Model No.	PJ-301-B
DIA	NON-THREAD
	$\phi 6.0$
Schematic	
Color	B:black

DESIGN	山楂	VIEW:	MODEL TYPE: 3.5 PHONE JACK
CHECKED		UNIT: mm/in	PART NO.: PJ-301-B
APPROVED		SIZE: A4	DWG NO.:

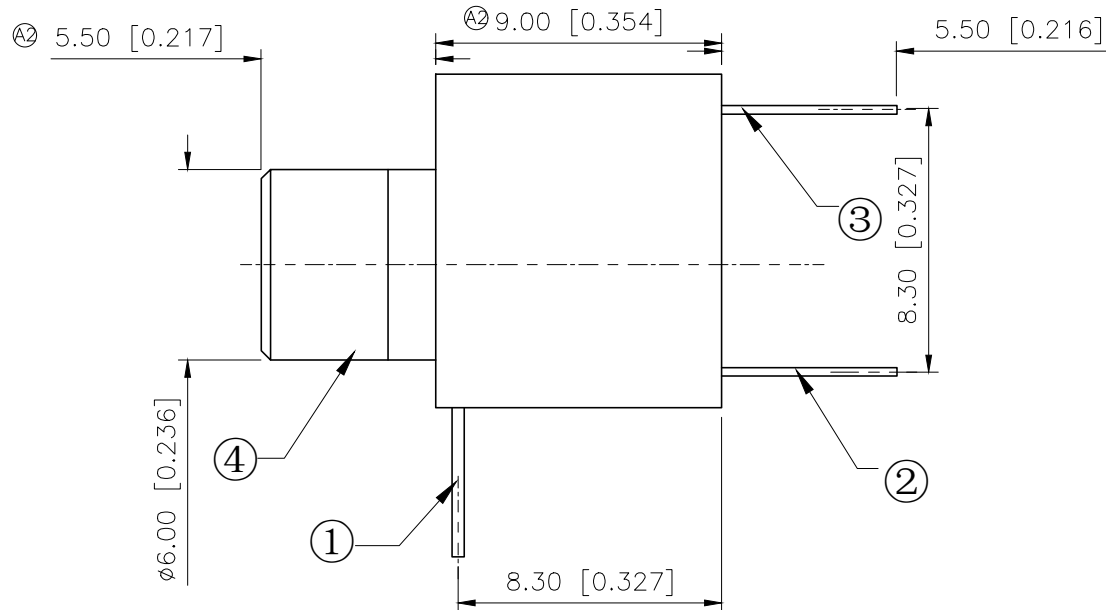
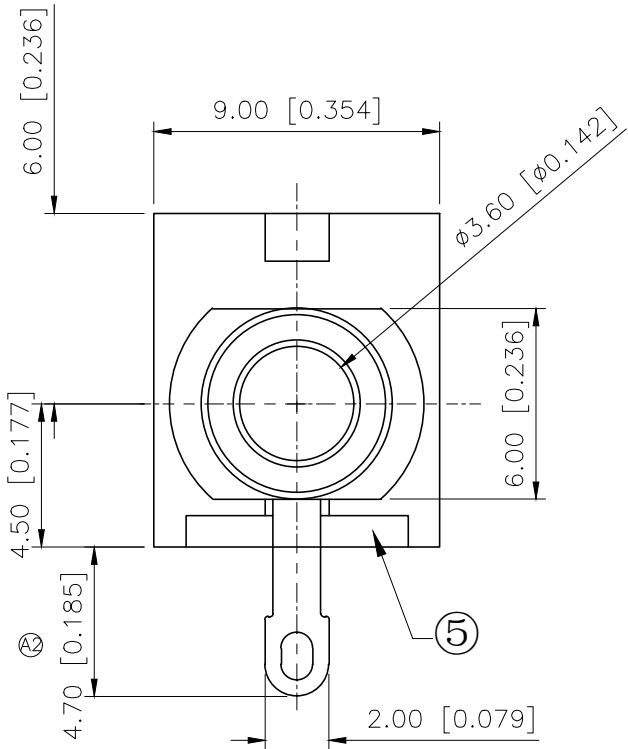
REVISIONS					
REV.	ECN NO.	LOCATION	DESCRIPTION	DATE	DESIGN
A1	N/A		图面升级整理图面	2025.06.26	阿树
A2	ECN-P-2026042403	②X3	产品外观尺寸及材质变更	2026.04.24	山楂
